TO: El Paso County
FROM: Element Engineering
DATE: March 25, 2023
SUBJECT: Town of Ramah Wastewater System Improvements Site Development Plan

EPC STORMWATER REVIEW COMMENTS
IN ORANGE BOXES WITH BLACK TEXT

TOWN OF RAMAH

WASTEWATER SYSTEM IMPROVEMENTS

WASTEWATER TREATMENT PLANT
POND GRADING PROFILES
TOWN OF RAMAH
113 S. COMMERCIAL STREET
RAMAH, CO 80832

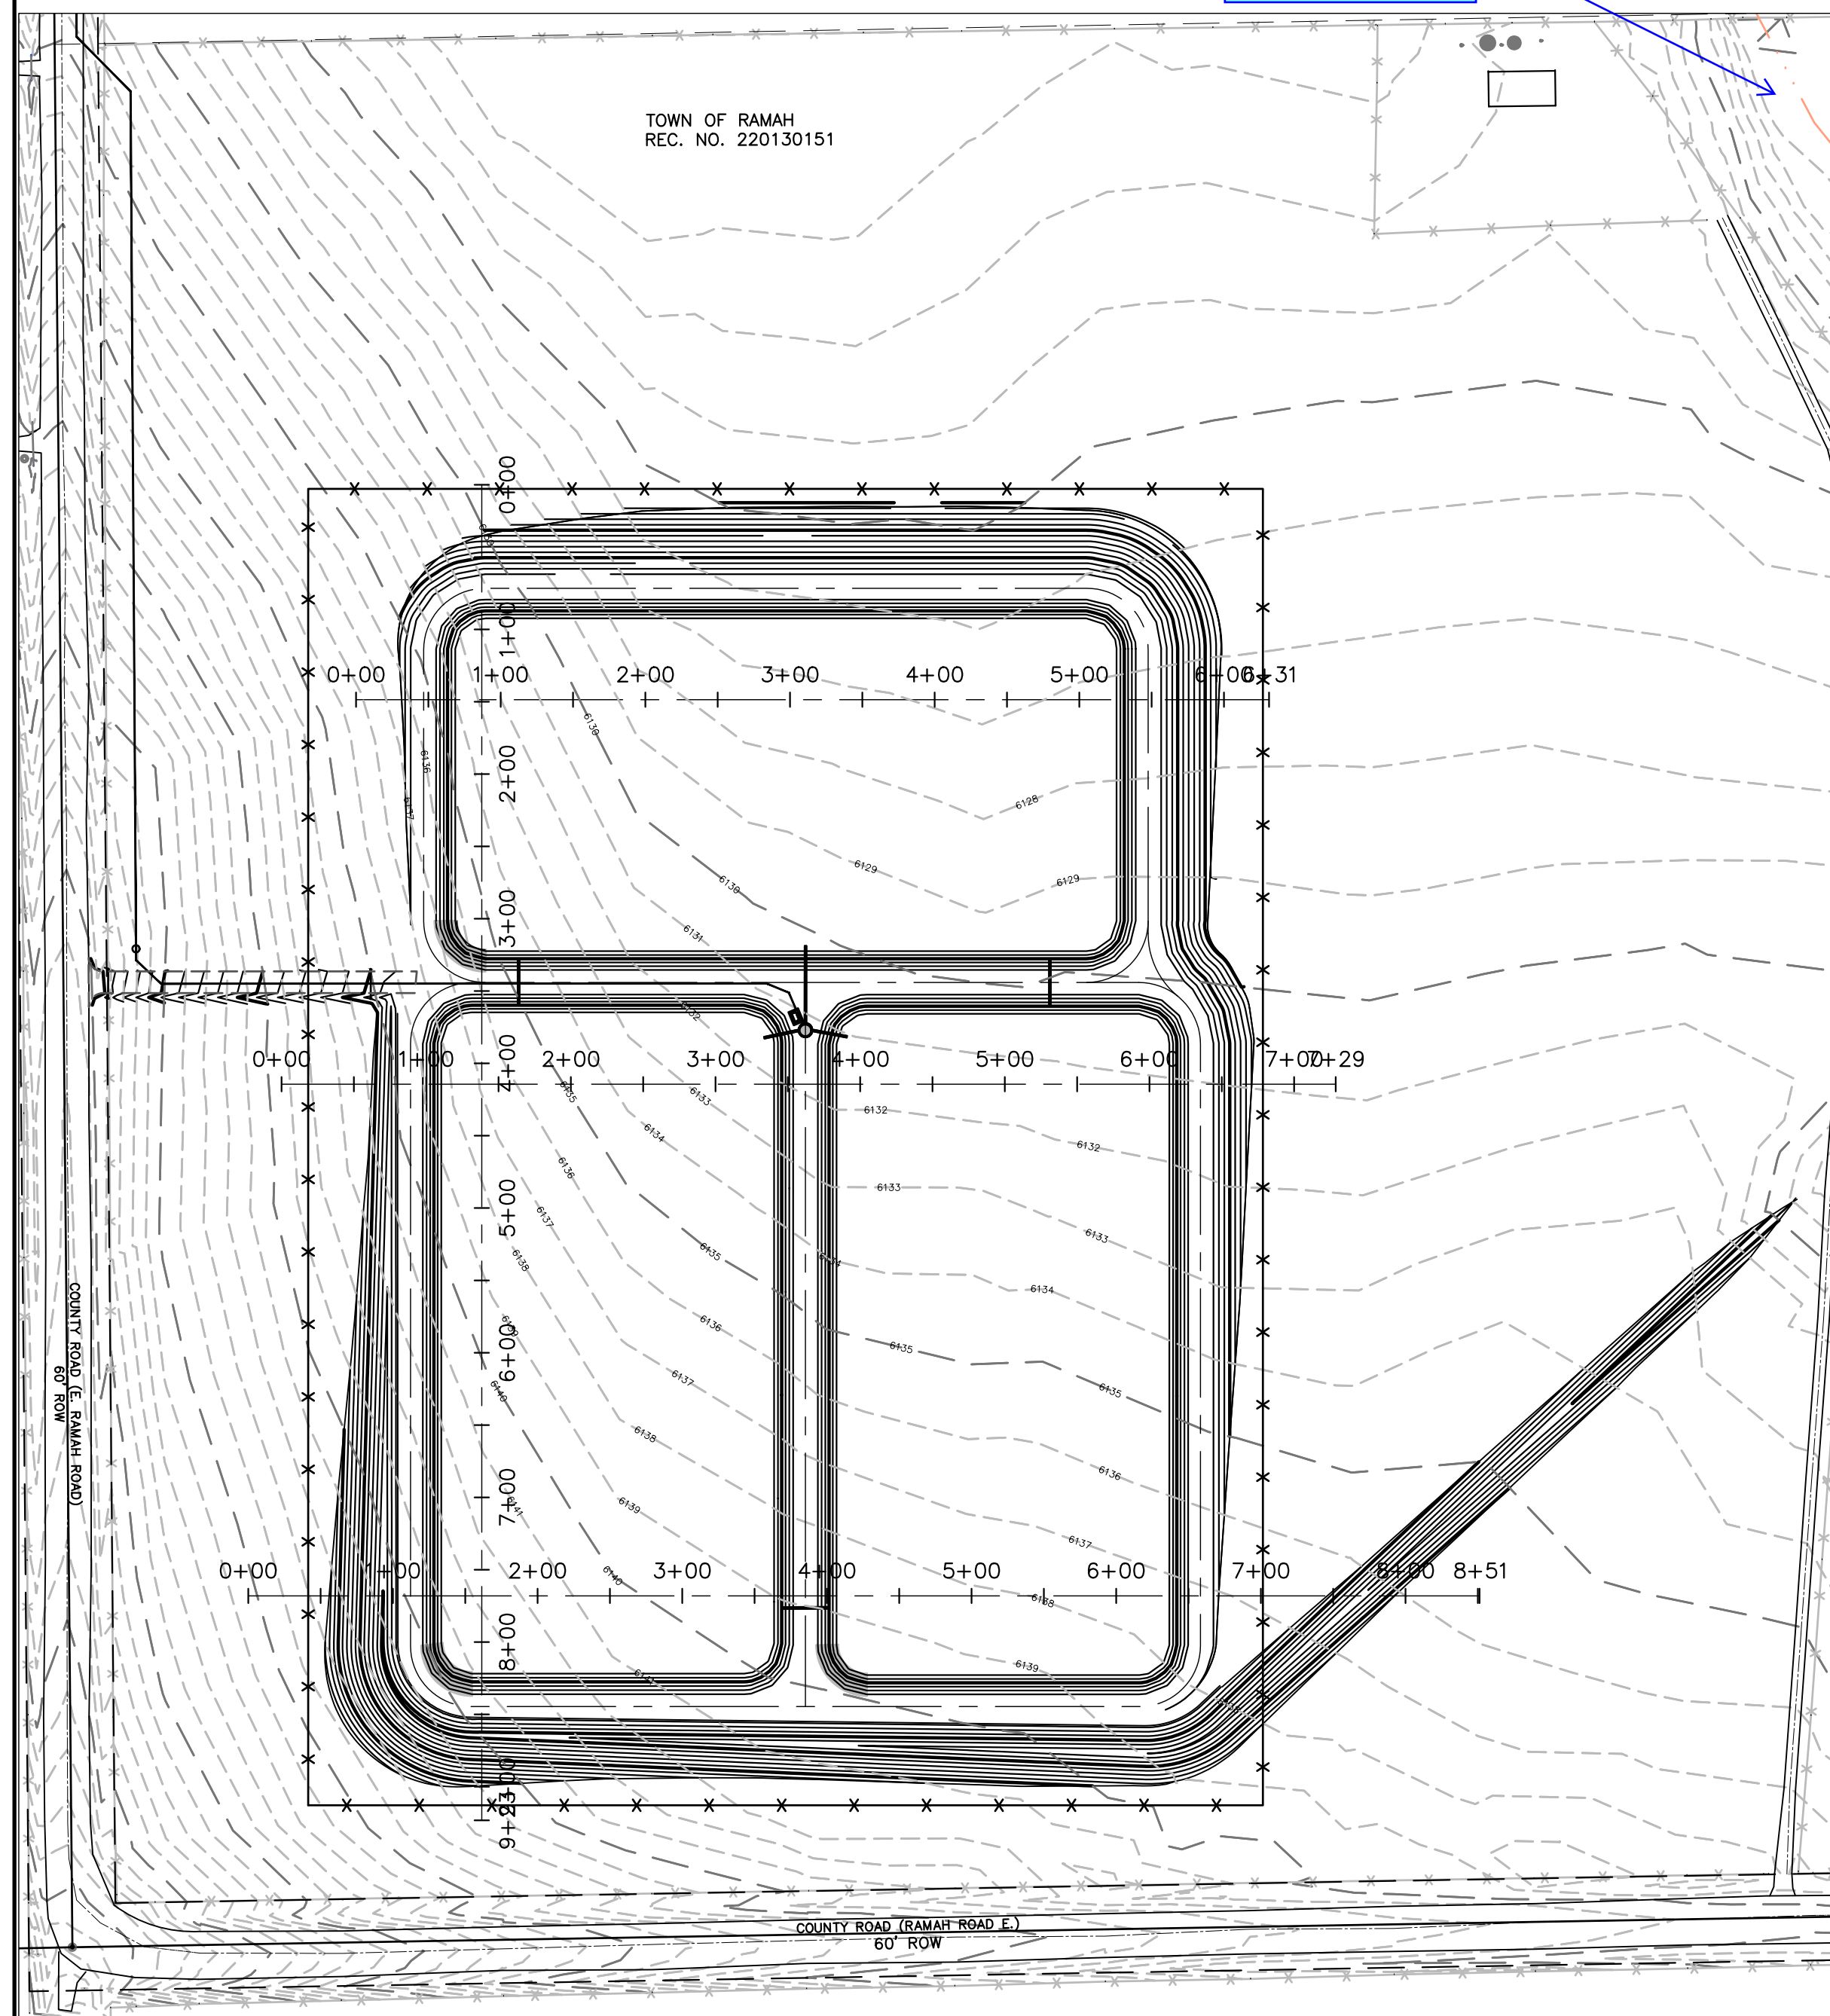
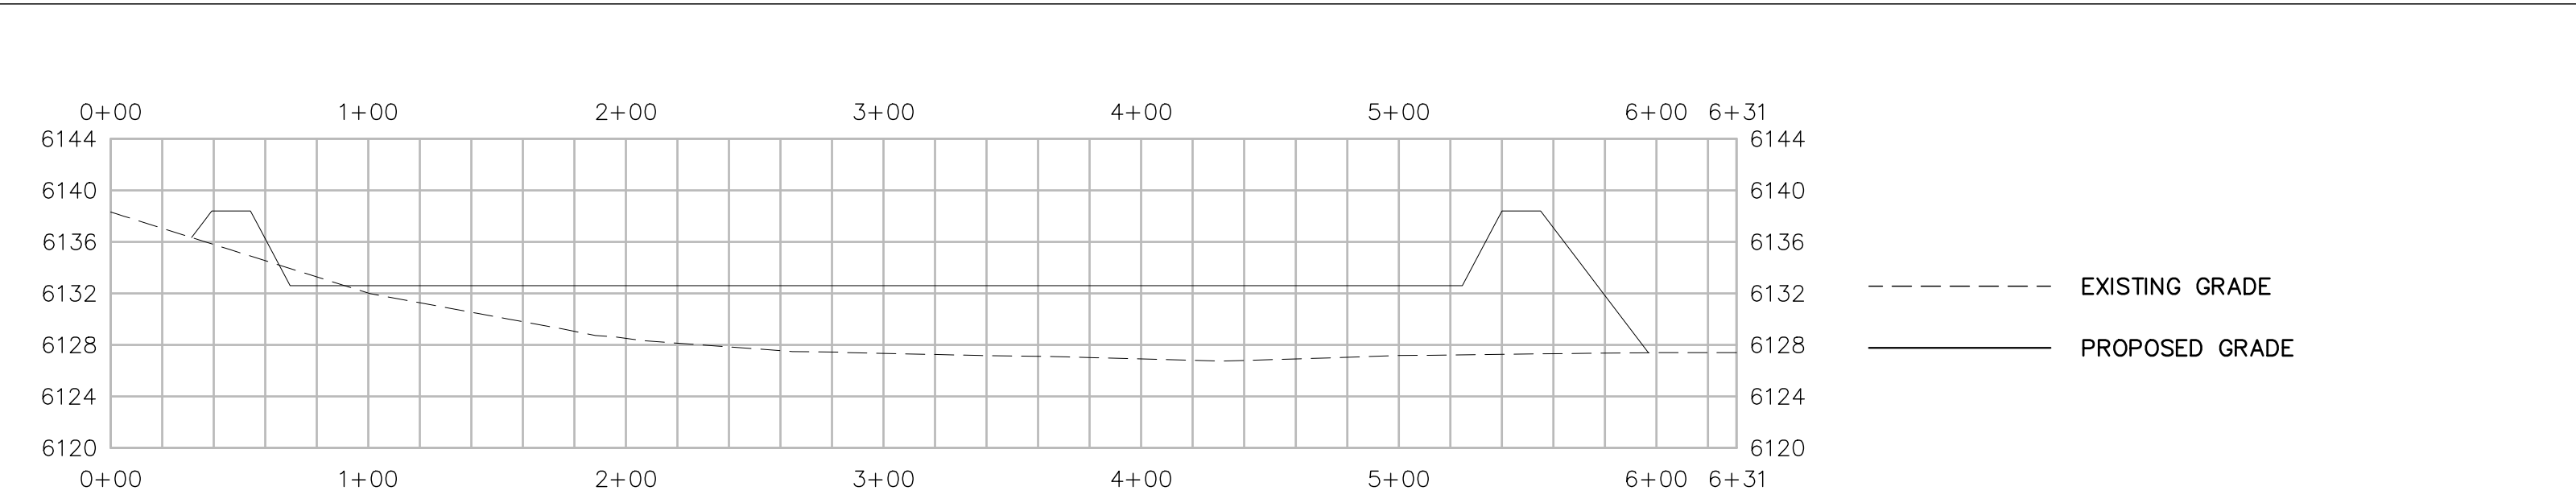
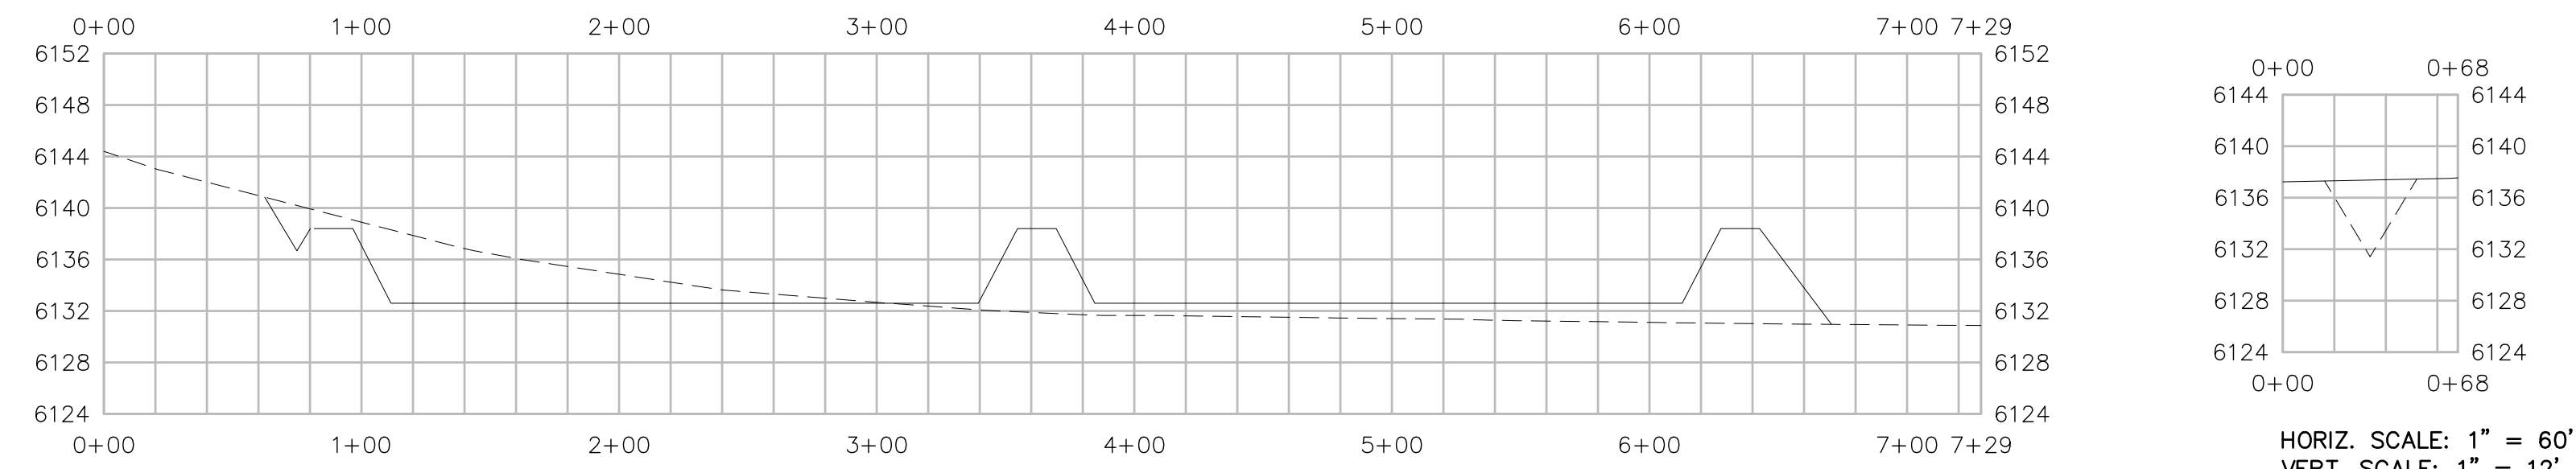
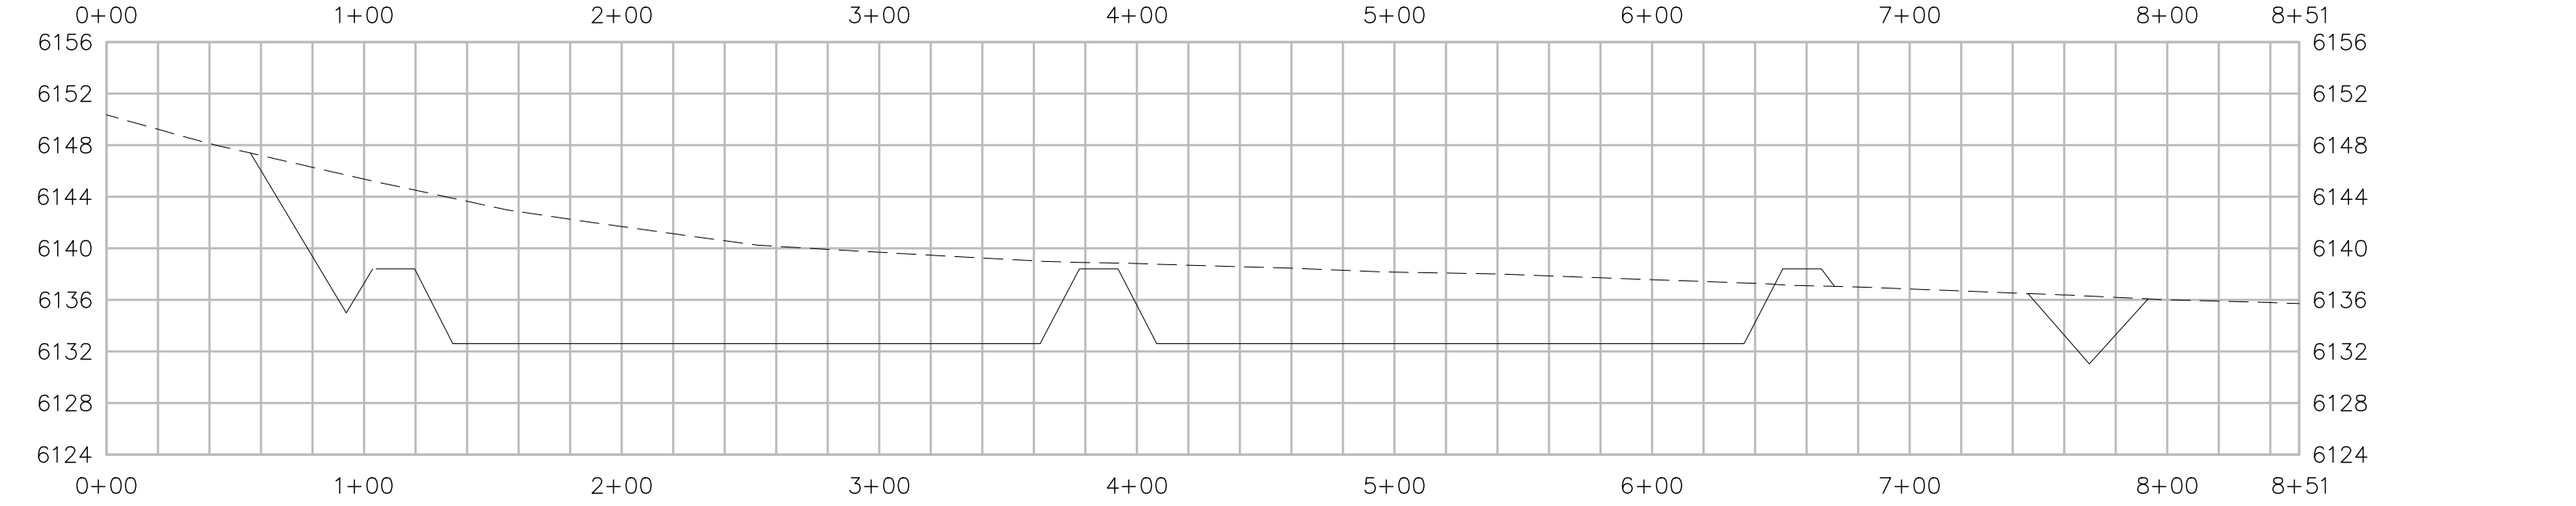
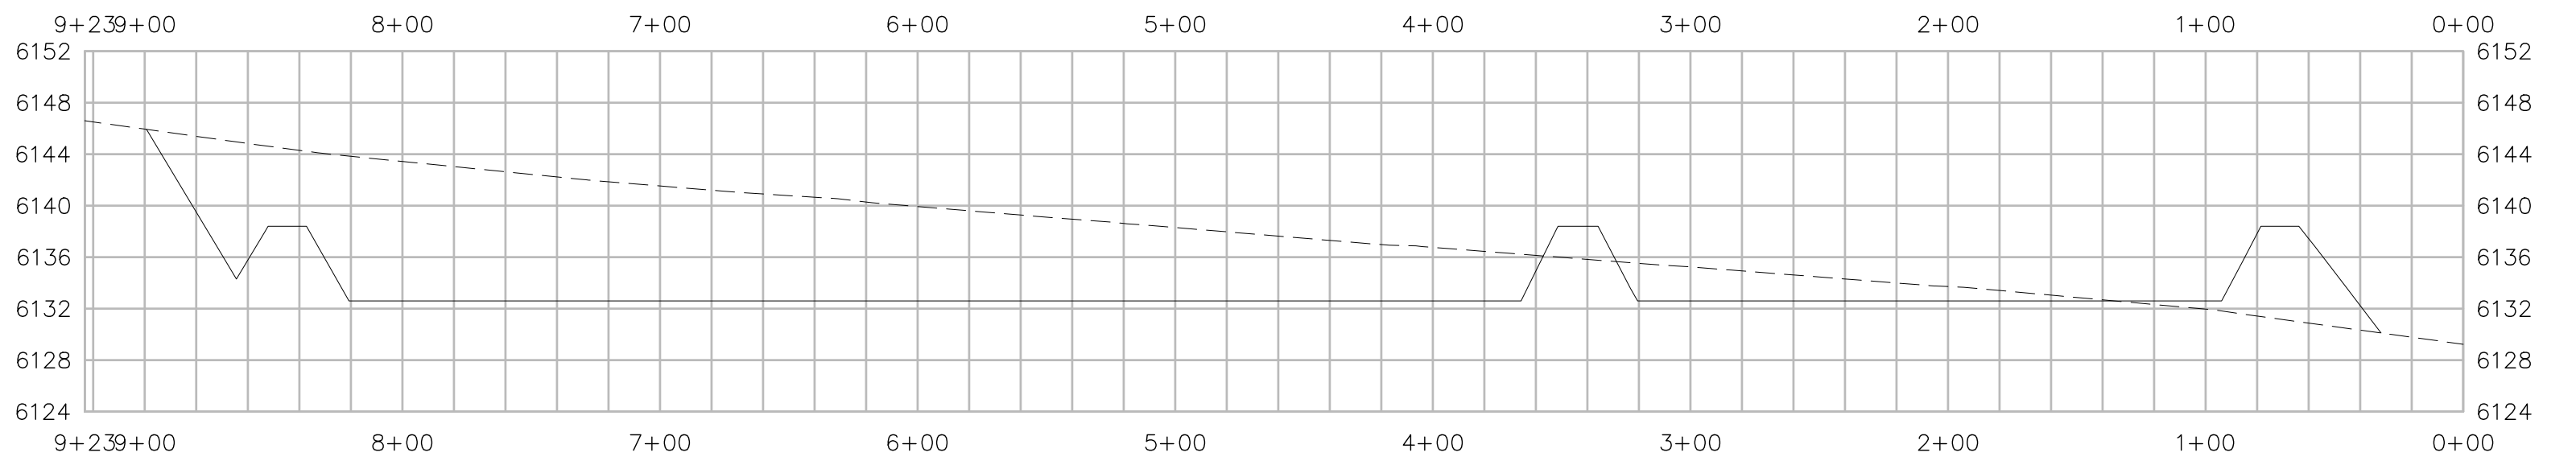
Identify floodplain boundary.
